Recommendation Meeting

3020 NE 45th Street
Seattle, WA 98105

04.10.2023 SDCI #3039169-LU

UNION BAY PLACE RETAIL FLOOR PLAN - EDG2

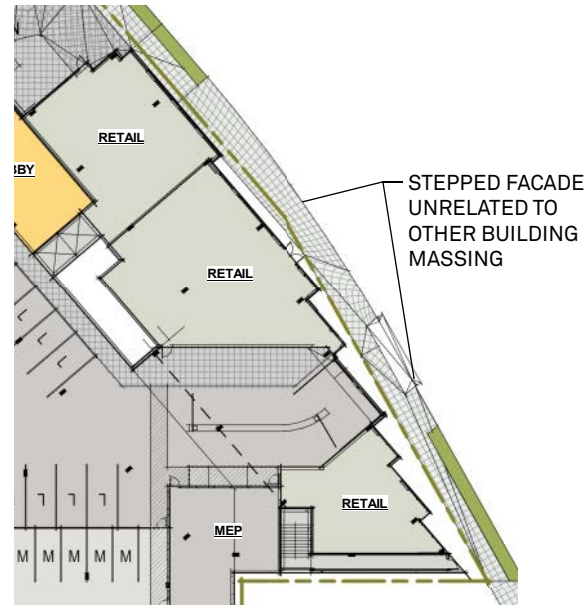
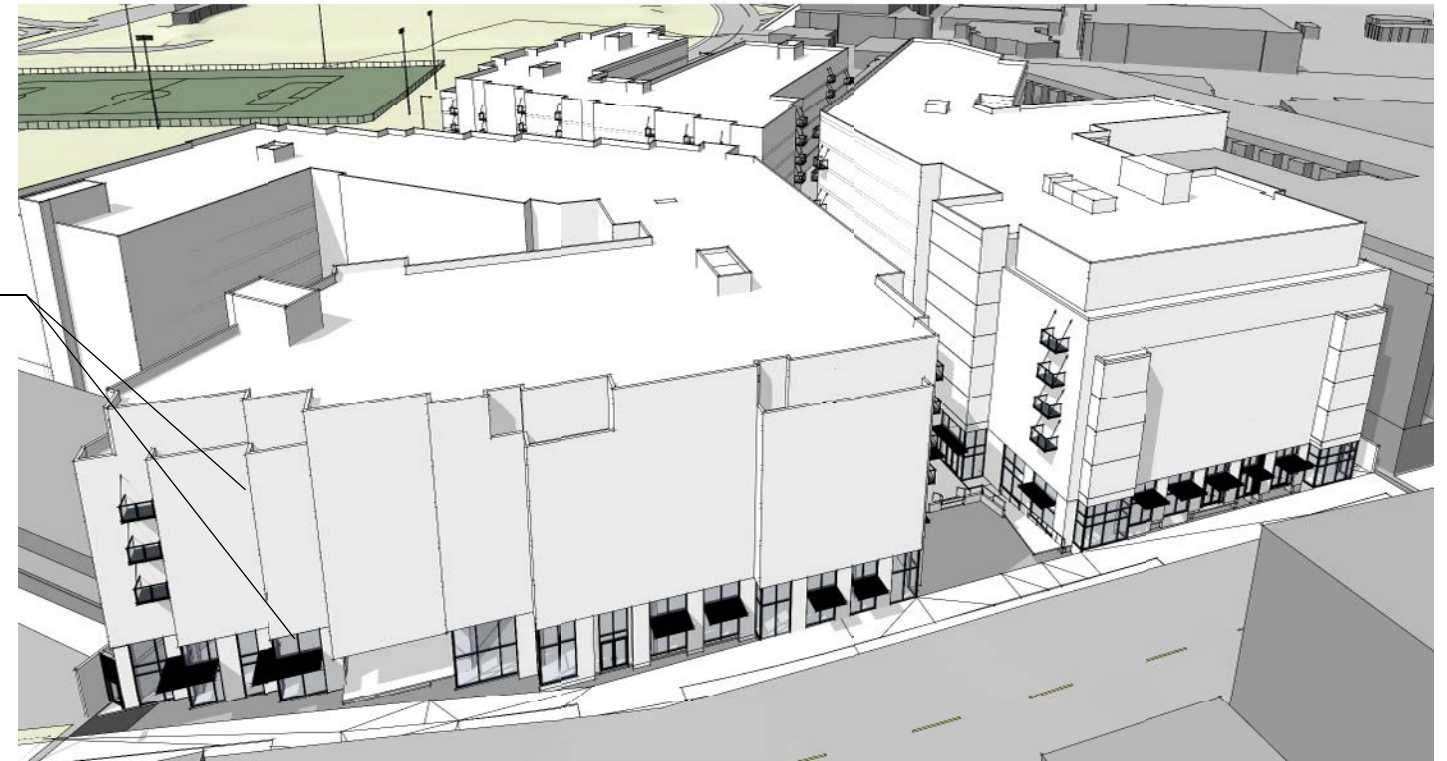
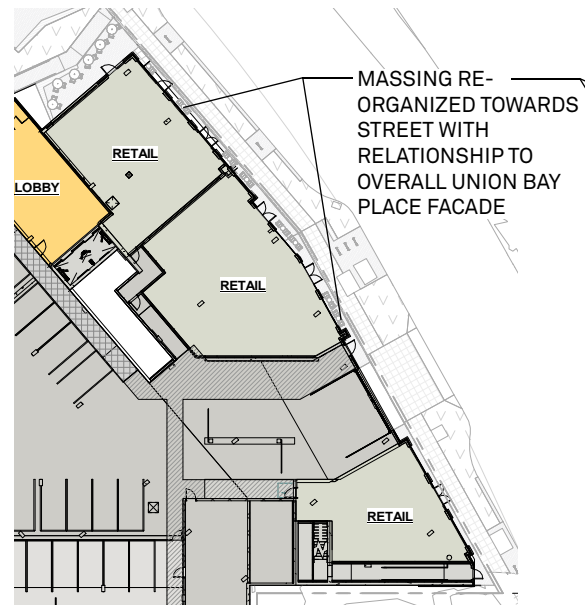
BOARD GUIDANCE EDG2-3A:

"The Board appreciated the design of the new plaza and street frontage along Union Bay and its relationship to the lobby, the 'book ending' retail and the connecting exterior stair. (CS2-B-2, CS3-1, PL1-A, DC4-B)"

BOARD GUIDANCE EDG2-3B:

"The Board voiced concern about the serrated building edge as it moves around the corner from Union Bay to 45th St and wondered what will happen with the associated retail spaces at ground level. As such the Board asked the design team to provide additional studies on the geometry for the retail space and design logic for how the frontage at southeast corner of the building has been shaped. (PL1-A, PL1-B.1, PL1-C)."

DESIGN RESPONSE

The massing and facade design along Union Bay Place has been re-configured to further develop and reinforce the "book ending" approach that the Board supported during EDG-2. The more simplified massing of the north building has been continued south of the plaza to provide a continuity of the design language along the entire facade, replacing the incongruity of the previous "serrated edge" which the Board had concern with. The building base has also been updated to better reflect the retail use and ground the massing, while the required upper level setback has also been simplified to create a more consistent relationship between the two buildings.

STREET FRONTAGE ELEVATION - UNION BAY PLACE NE

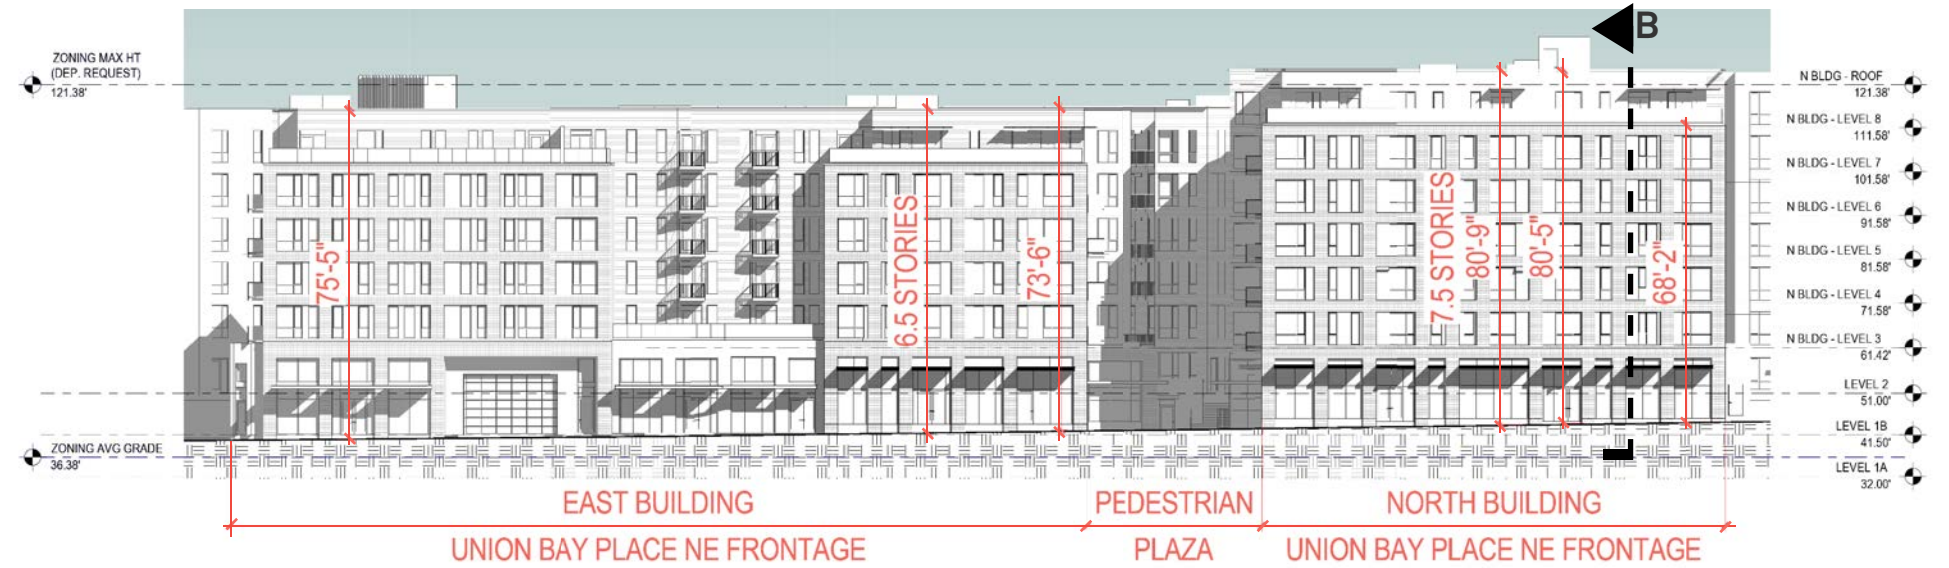
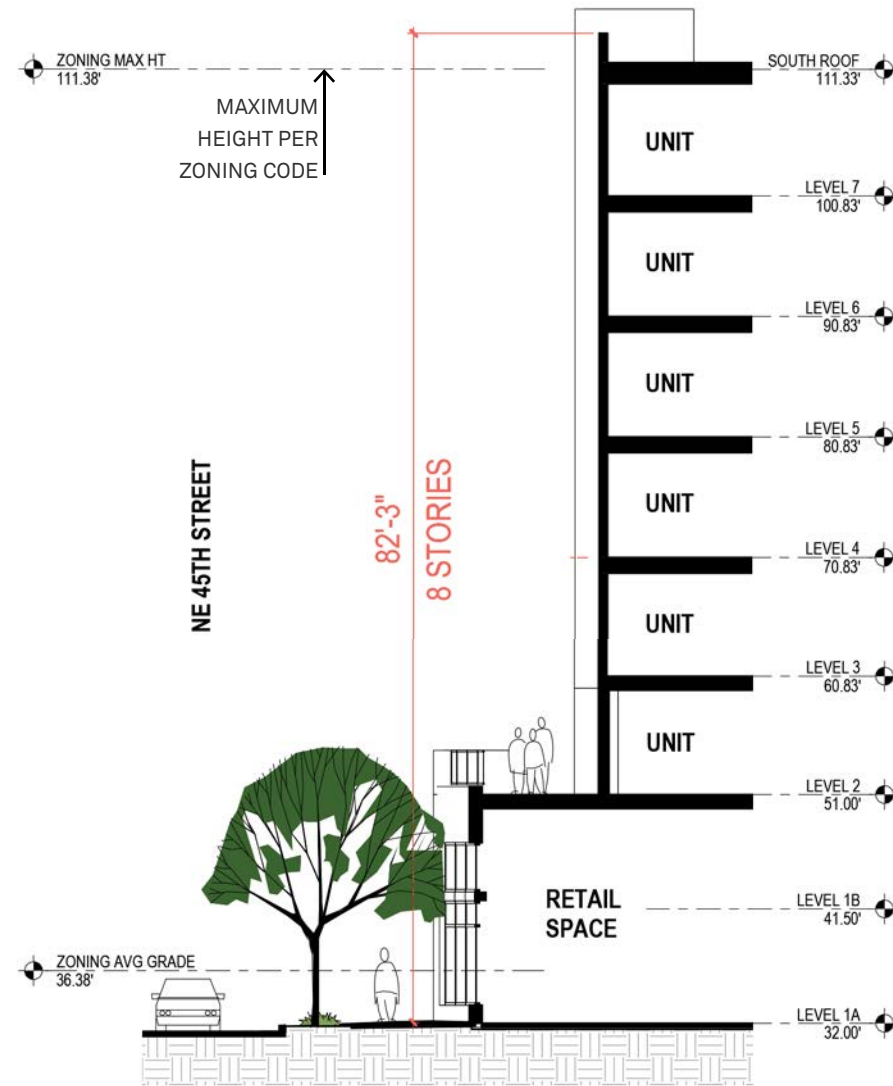
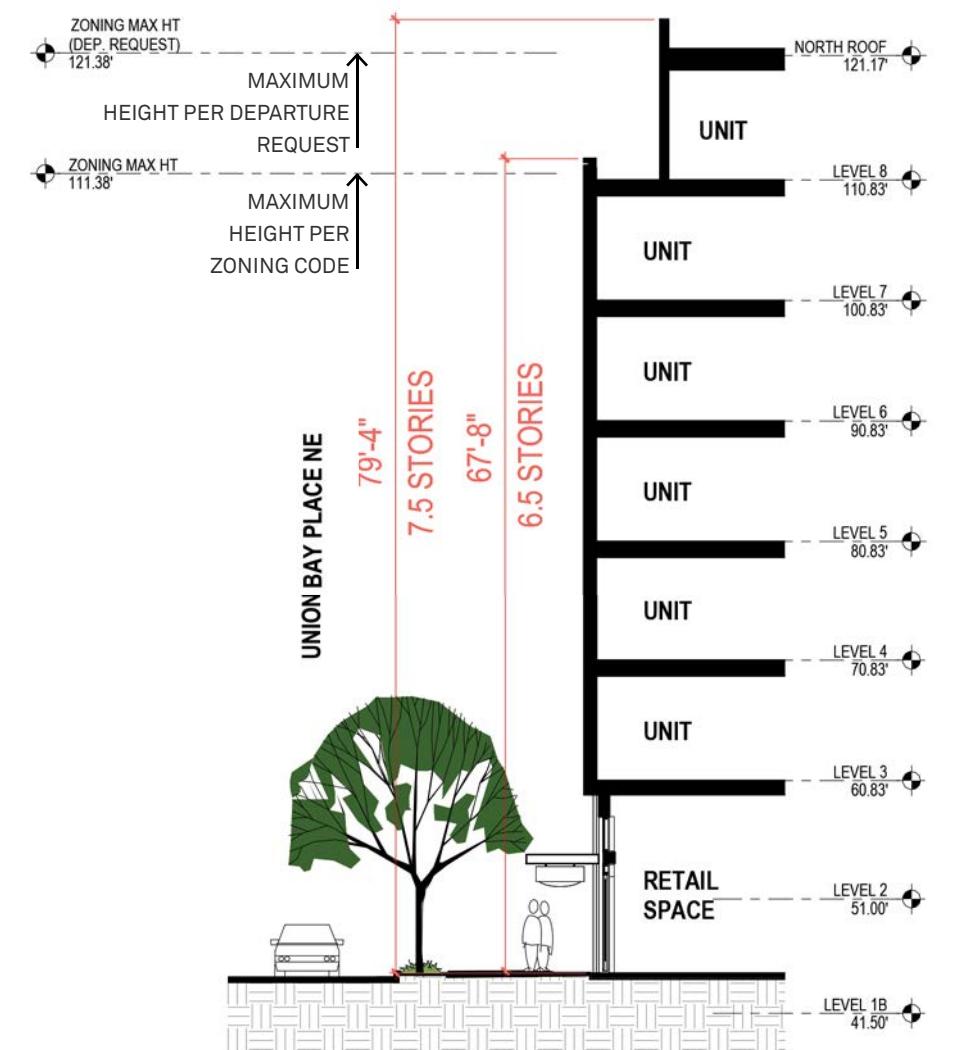
BOARD GUIDANCE EDG2-4A:

"In their deliberations, the Board supported the additional height requested for the northern building as it relates to the departure request. The Board did, however, request continued discussion during its review of the departure for additional building height below. CS1-B, CS1-1.a, CS2-D)."

DEPARTURE REQUEST #2 - BOARD RESPONSE:

"The Board indicated its preliminary support for the departure request given the applicant's rationale about the addition of a floor to the north building which compensates for the reduced footprint necessary to retain the exceptional tree without losing development capacity and the broader opening for the south facing courtyard space. CS2 - URBAN PATTERN AND FORM, DC2-B ARCHITECTURAL AND FAÇADE COMPOSITION, CS2-D HEIGHT, BULK, AND SCALE, CS2-2-b. PROVIDE ZONE TRANSITIONS."

DESIGN RESPONSE

With the Board's support for this departure request, the project has moved forward with the preferred massing option, which uses the additional height requested to add an additional floor to the north building, allowing for redistribution of massing to create the proposed pedestrian plaza along NE 45th Street, retaining the exceptional London Plane tree at this location. See Section 17, Departures, for diagrams and rationale regarding this request.

A MASSING STUDY PLAN

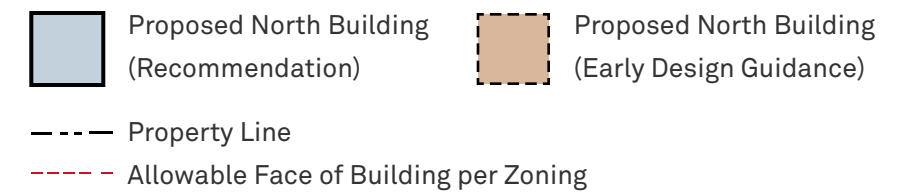
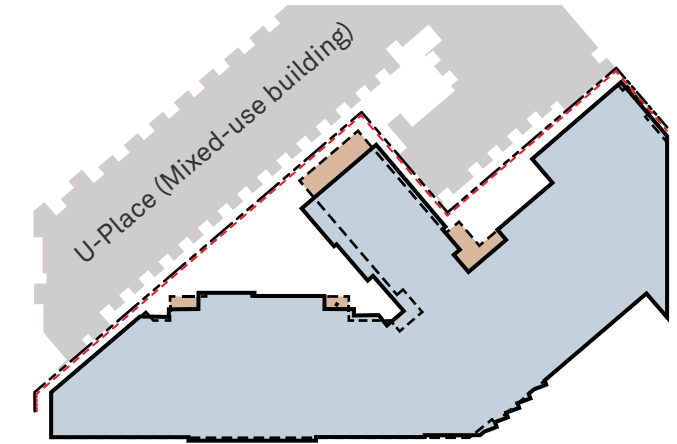
Board members had questions about the relationship of the northern portion of the building and its relationship to the existing development at University Place as seen on page 22 of the EDG 1 packet. Members observed that there are six units multiplied by five stories that will face a wall which they felt would be problematic. Based on this discussion, the Board directed the design team to provide additional information and detail on what the space will look like including privacy studies or resolve the concern by potentially pulling the units back, provide a buffer between any blank wall condition and impacted units or otherwise show how the scale has been mitigated. (CS2-A-1, CS2-A-2, CS2-B-2, CS2-C-1, PL1-A, PL3, PL3-2-c, DC3-1)

BOARD GUIDANCE EDG2-4B&C: BUILDING HEIGHT

- b. The Board asked the design team to provide more information on the relationship between the northern building receiving the additional height and U-Place, especially in terms of the 'unit to unit' relationships (related to privacy. (CS1-B, CS1-1.a, CS2-B, CS2-D, DC1-A-4)
- c. The Board asked the design team for more information on how the additional height will affect the single-family residences to the northeast as well as University Place in terms of view impacts and privacy studies especially in relationship to. (CS1-B, CS1-1.a, CS2-B, CS2-D, DC1-A-4)

DESIGN RESPONSE:

The north wing of the north building has been reconfigured to provide more space between the new and existing buildings where units facing each other occur. Where the proposed north building units occur close to blank walls on the U-Place building, the primary living spaces of these units have been re-oriented towards on-site open space. Bedrooms have been located where the two buildings are in close proximity.

DESIGN RESPONSE:

The north wing of the north building has been pulled back away from U-Place to maintain views and daylight access to the U-Place units. This also serves to extend and connect the U-Place courtyard into the proposed north building's courtyard. Additionally, a stair core has been removed from the northeast courtyard increase the size of the open space and to provide better access to view and daylight from the end unit of U-Place.

BACK WALL OF COURTYARD

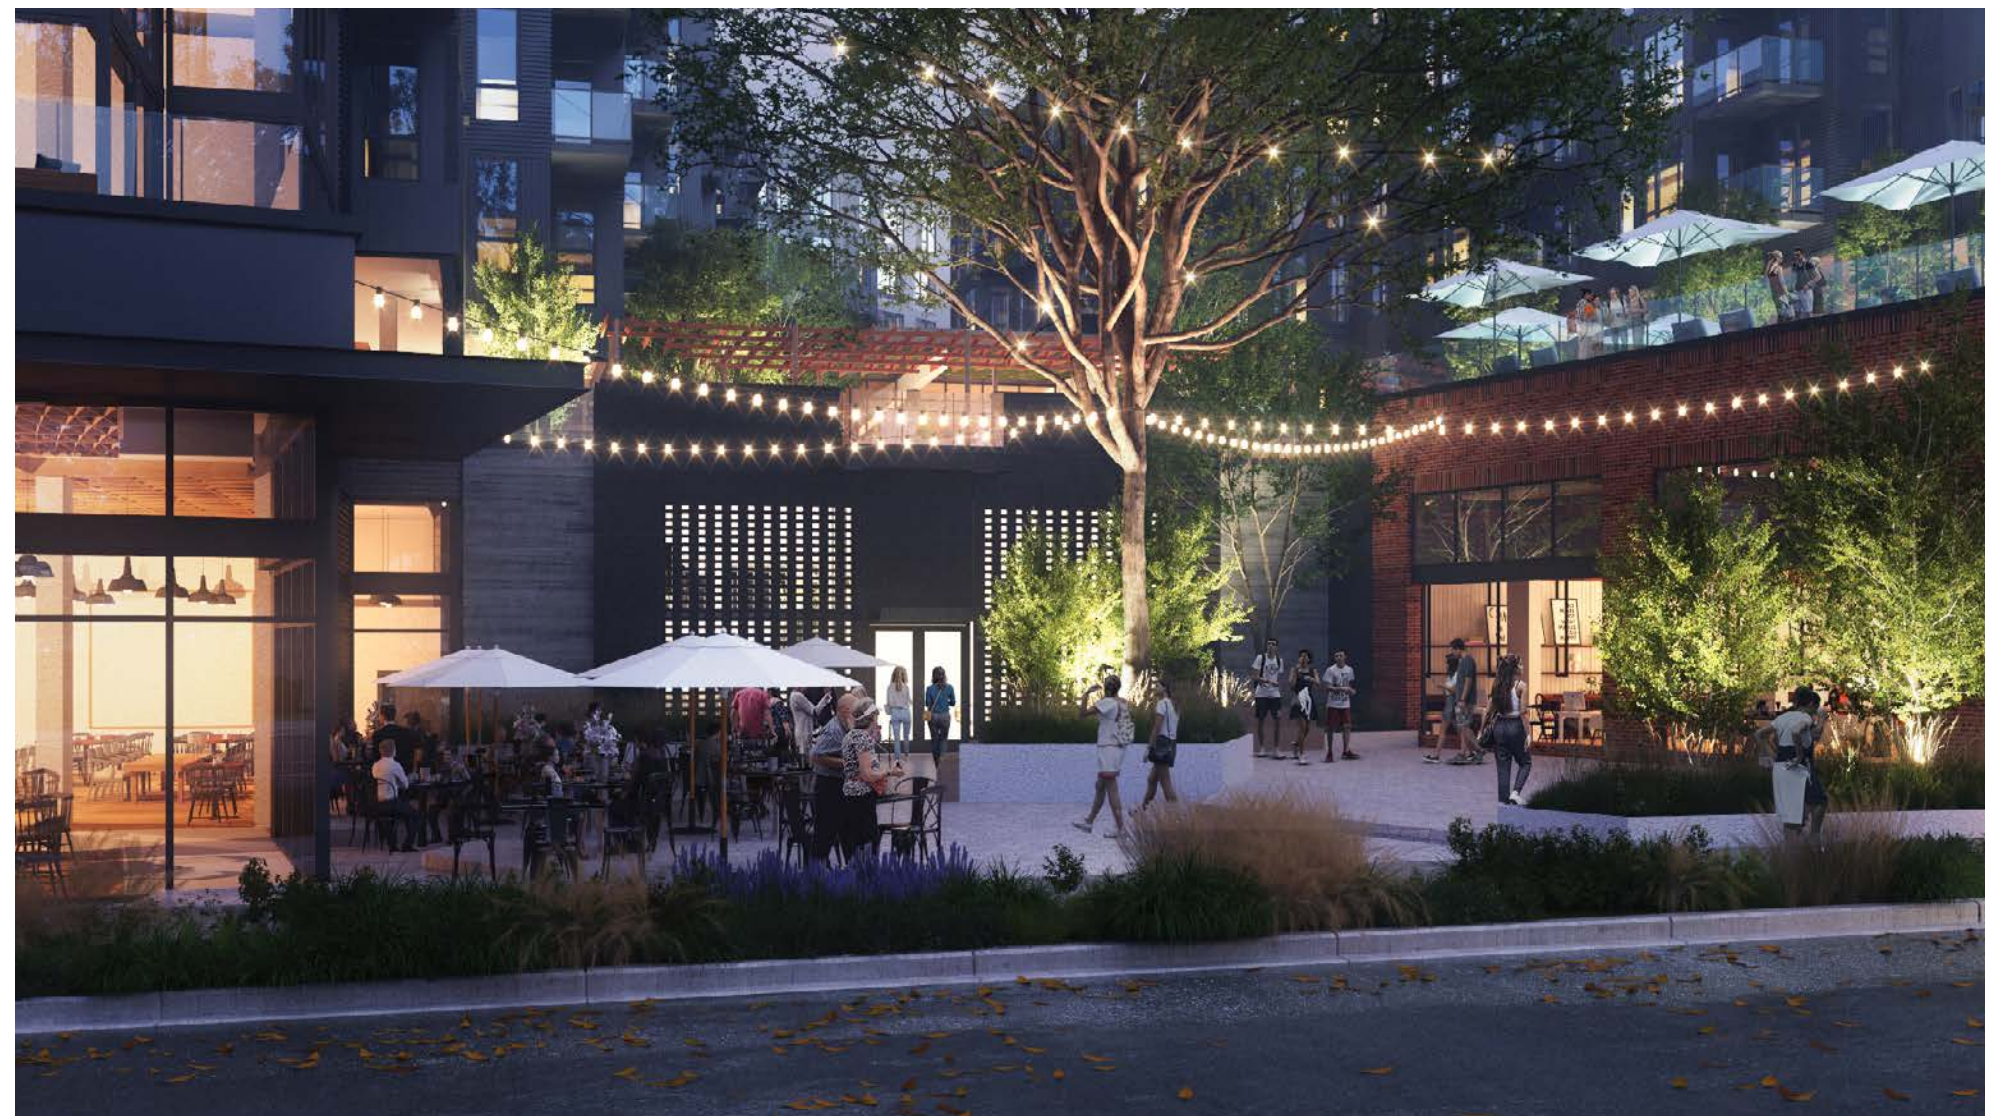
EDG Response - NE 45th Streetscape - Back Wall of Courtyard

DESIGN RESPONSE

The back wall of the public courtyard on NE 45th Street has been reconfigured as a central design element framing this space.

The wall features a brick lattice finish that provides a textured granularity while allowing airflow to the garage beyond. A door connects the garage to the retail spaces around the courtyard. At the top of the wall, the design features a prow-like balcony with glass railing, providing an overlook from the plaza above.

VIEW LOCATION PLAN

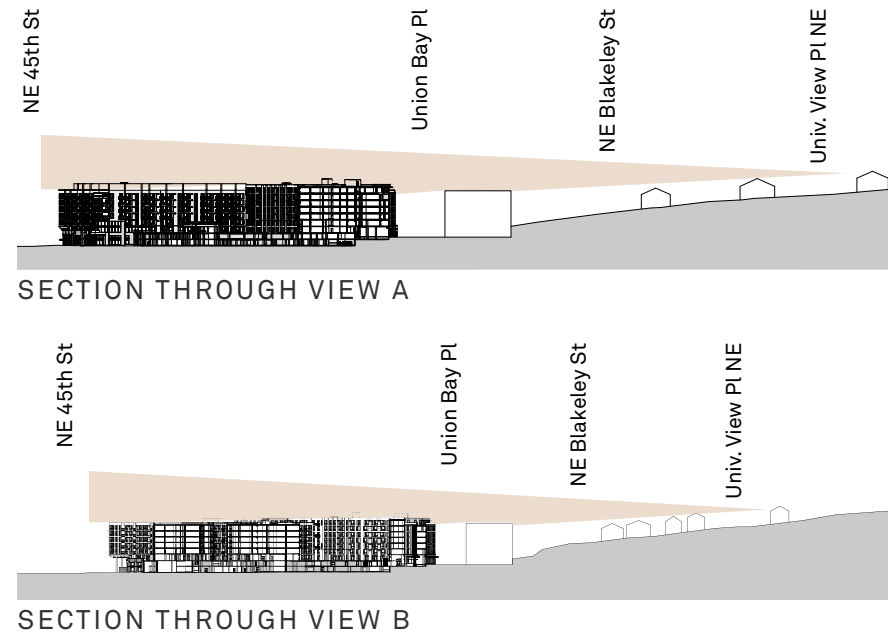
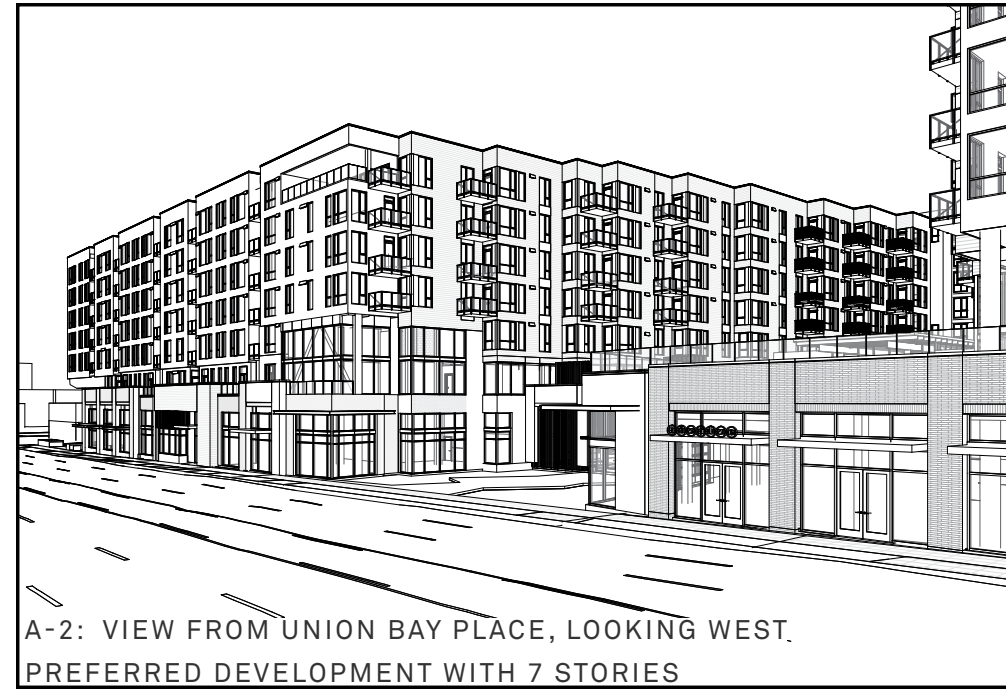
BOARD GUIDANCE EDG2-4C:

"The Board asked the design team for more information on how the additional height will affect the single-family residences to the northeast as well as University Place in terms of view impacts and privacy studies especially in relationship to. (CS1-B, CS1-1.a, CS2-B, CS2-D, DC1-A-4)."

DESIGN RESPONSE

(Note that view studies from University Place are provided as part of the EDG Response to Board Guidance EDG2-1b).
